Roads and Maritime Reference: SYD18/00093/08
Council Ref: 1/2018/PLP

PLANNING PROPOSAL – DRAFT DEVELOPMENT CONTROL PLAN 2012 AND DRAFT VOLUNTARY PLANNING AGREEMENT AT 55 COONARA AVE, WEST PENNANT HILLS

SIDRA Modelling Report Ason group report dated 1 August 2018 – TCS 2575 **Review comments:**

SCATS VOLUMES

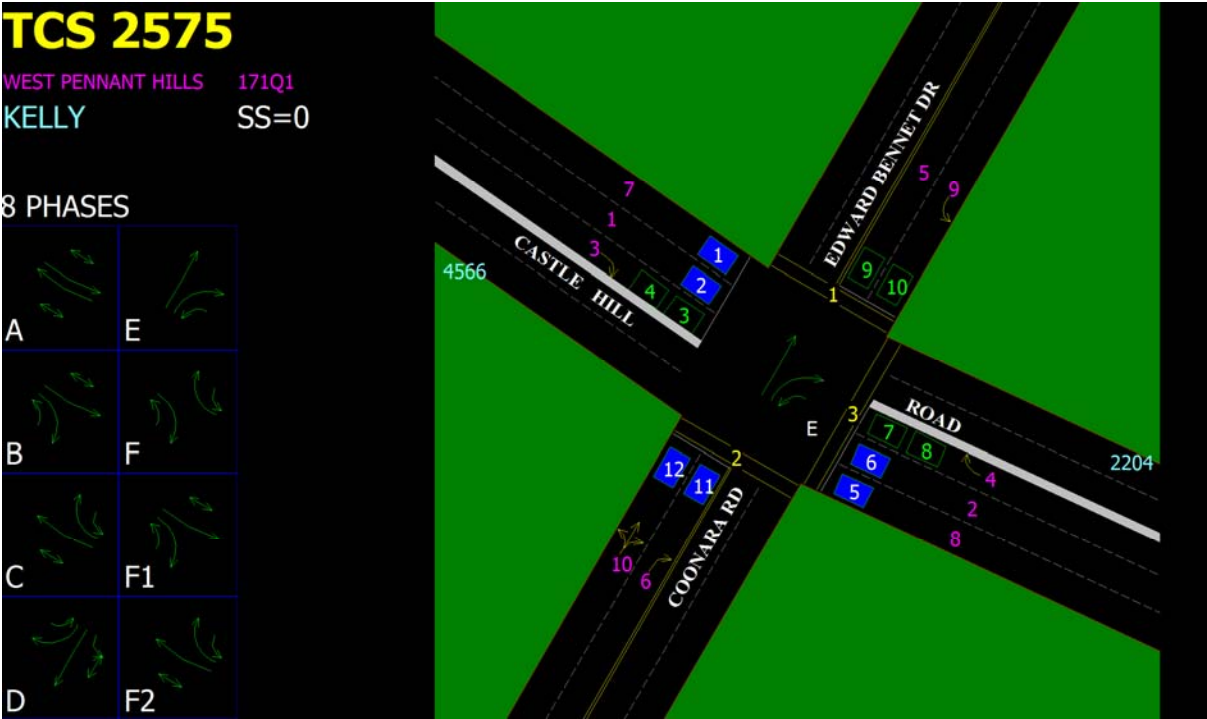
- The exact date of the traffic survey has not been supplied in this report and therefore cannot be verified. However, analysis was undertaken of the SIDRA volumes against the SCATS output files 2018 for the intersection of Coonara Avenue and Castle Hill Road. Based on this data it is noted that the traffic volumes used to model the existing scenario are lower than the traffic counts from SCATS. It is further noted that Google typical PM peak queues show a high level of queuing in Coonara Avenue and Google Live traffic queuing in PM peak period in all directions. This queuing is different to what the base model supplied by the proponent. The justification is located in **Tab B**.

EXISTING(LEFT) VS PROPOSED (RIGHT) MODELLING VOLUMES

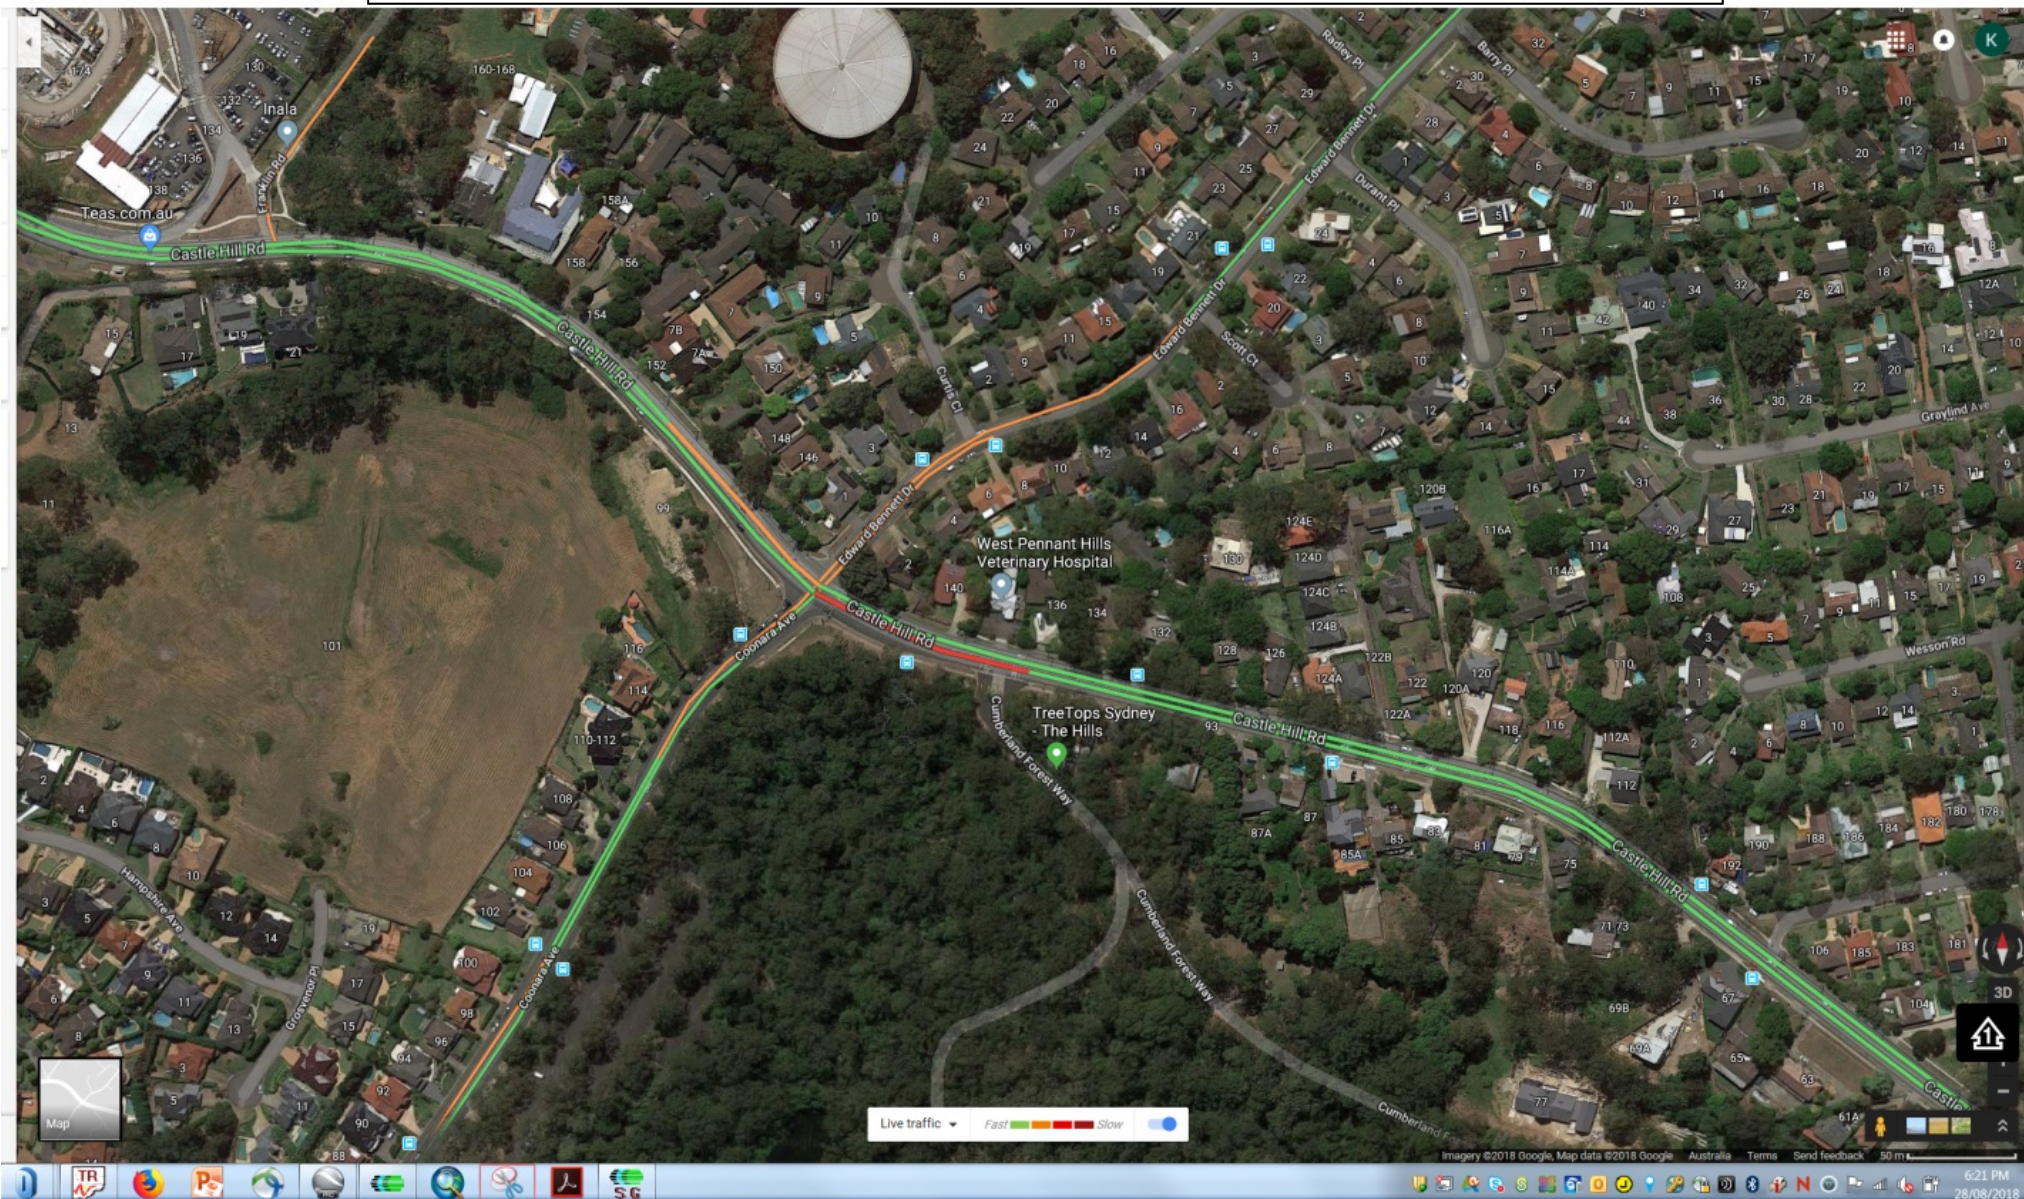
- As Roads and Maritime does not have details of the proposed zoning and FSR controls it cannot be confirmed whether the trip generation assumptions are appropriate. However, based on the analysis of the SIDRA output files it is noted that there is an additional 189 veh/hr (392-202) in the AM peak period in the modelling scenario. These additional volumes are lower than what Council’s Planning Proposal report received by Roads and Maritime in December 2017 indicated. See justification located in **Tab C**.

- The signal phasing under AM proposed scenario shows conflicting vehicle movements with pedestrian movements. It is necessary to revise the proposed scenario phasing system. The revision should separate vehicles from pedestrian movements when filtering is not possible.
